## PLANNING COMMISSION STAFF REPORT

AGENDA ITEM: Planning File No. MAJ-23-0012: A sketch plan review of multifamily residential development located at 160 Forest Drive

LOCATION: 160 Forest Drive / LOT 2 WEST FRISCO 70 SUB # 2

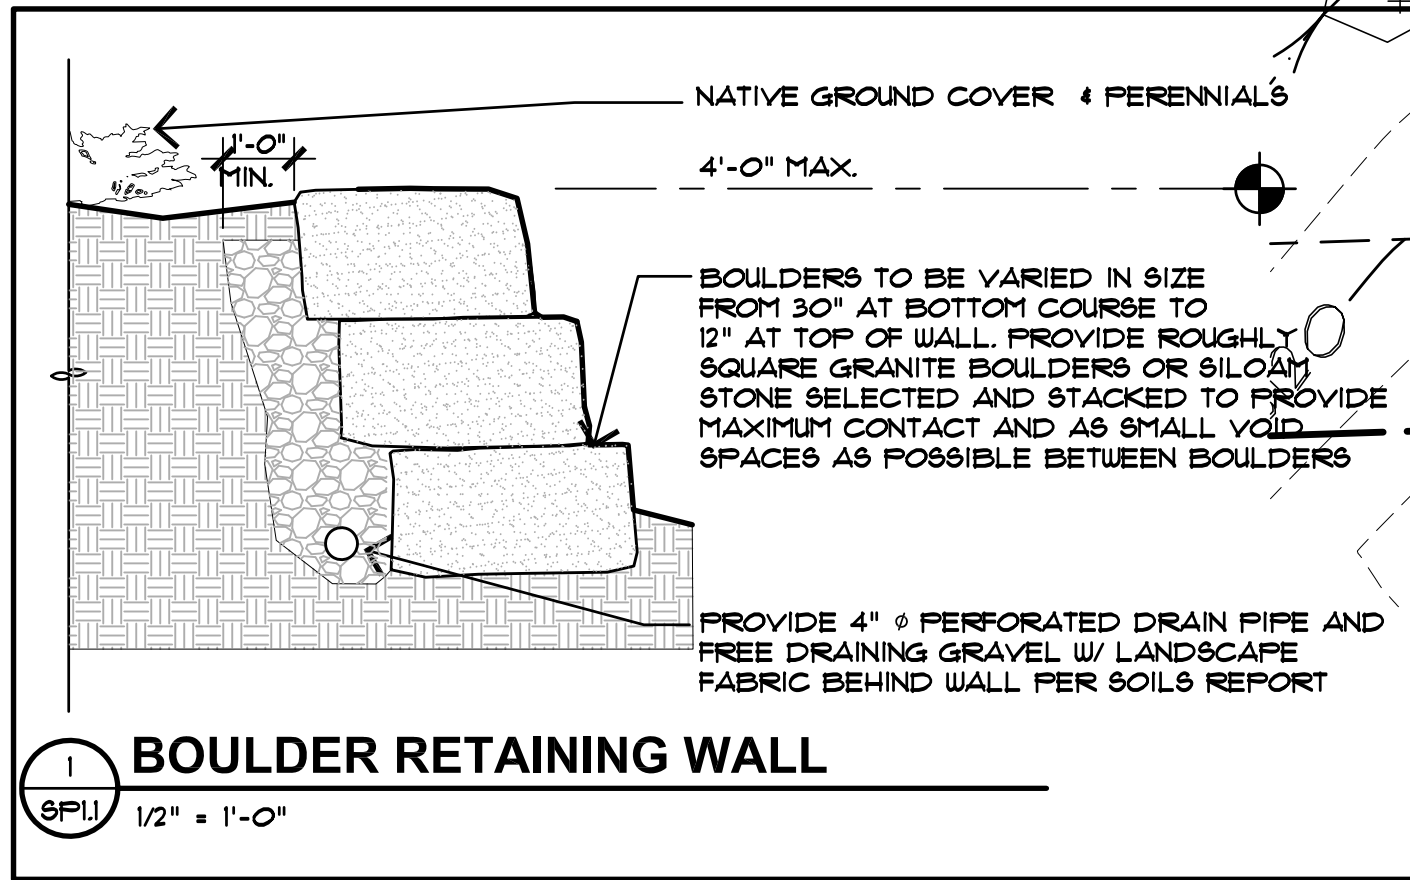
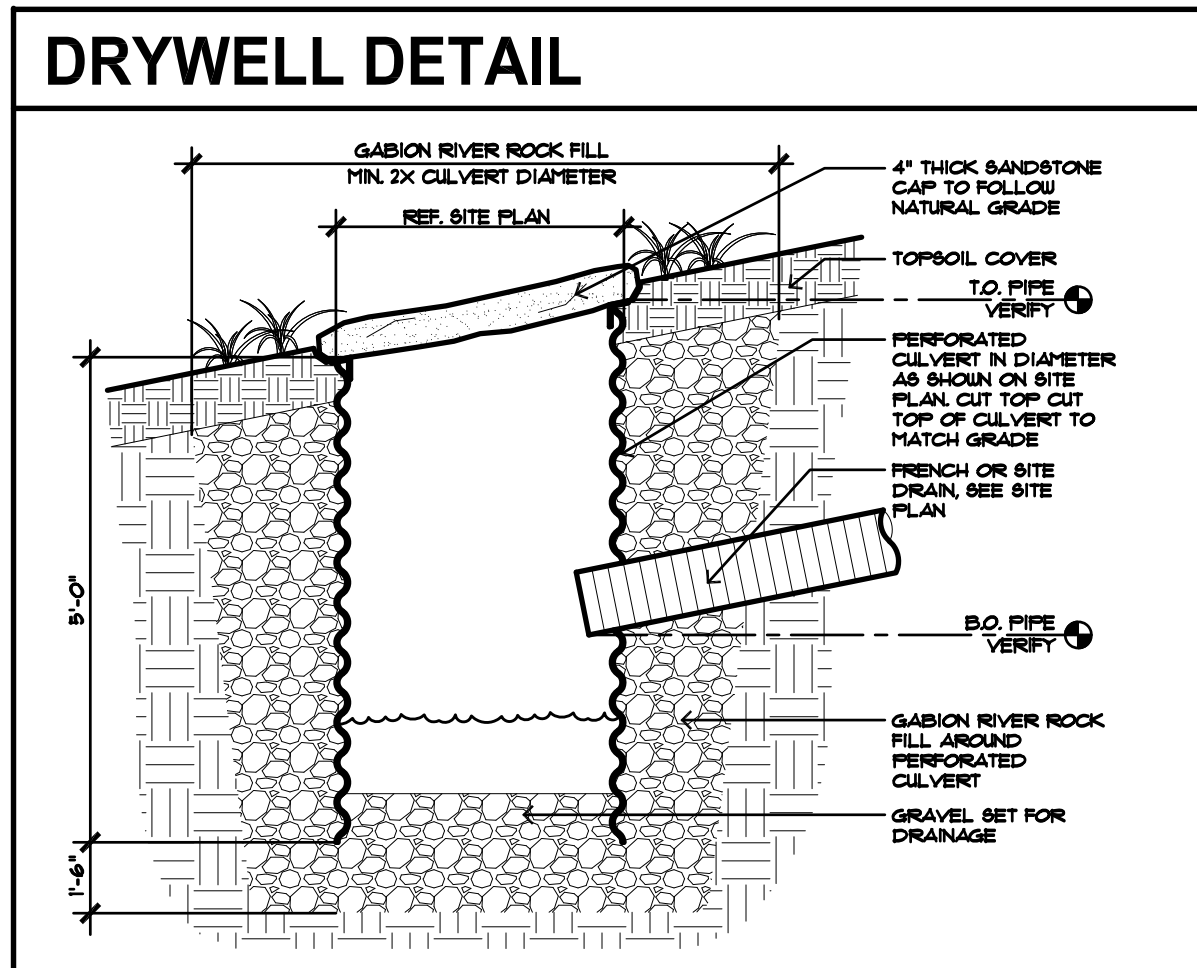
The building design does not duplicate other buildings within a 300-foot radius of the property, however, the units appear to be duplicative and use repetitive patterns. This appears on all elevations. See the east elevation below as an example.

**SITE GRADING PLAN**

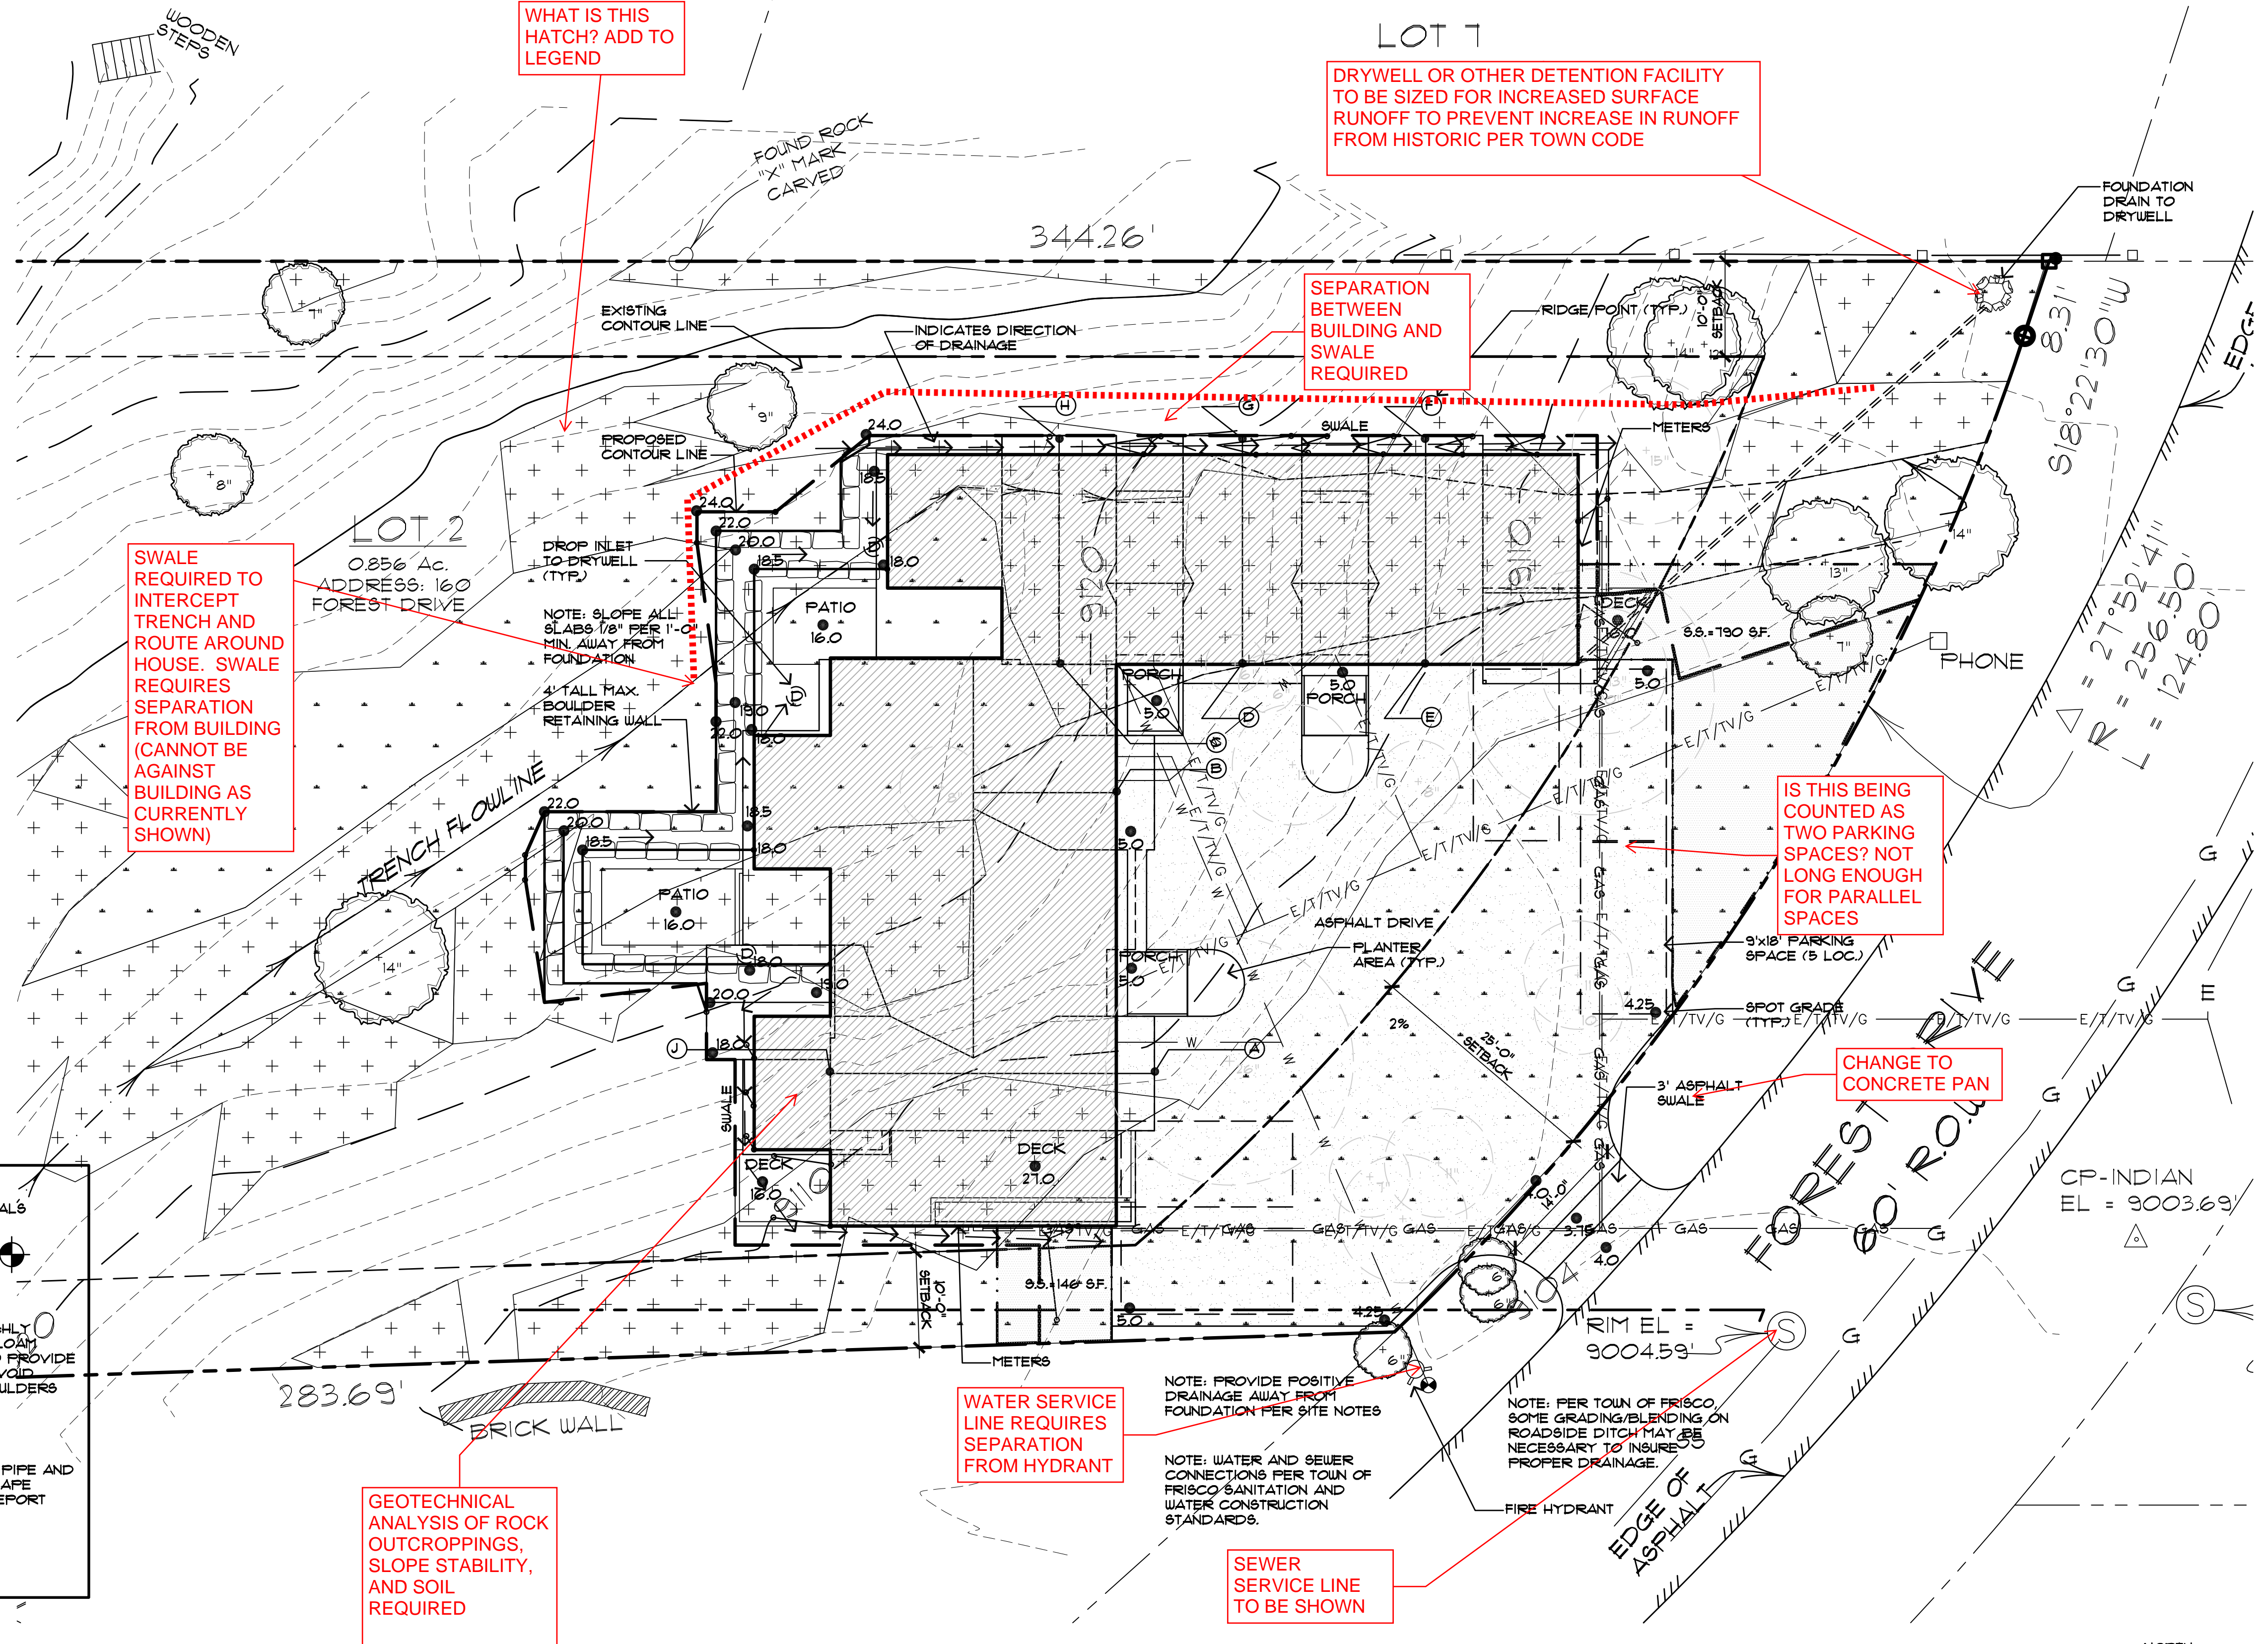
TOF ENGINEERING COMMENTS 12-20-23
